DMA Command Description Cleanup

Document 94-063r5

This document was prepared for the 14 March 94 ATA Extension WG meeting in Newport Beach, CA.

9.5.2 DMA transfer terminated by an error during data transfer.

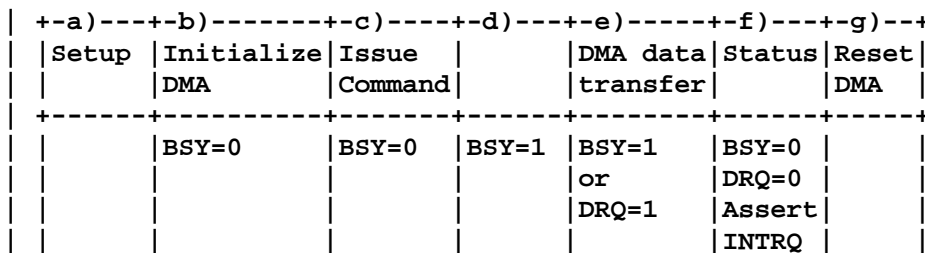
* 9.5.2 Aborted DMA transfer -- I recommend that this section be replaced by:
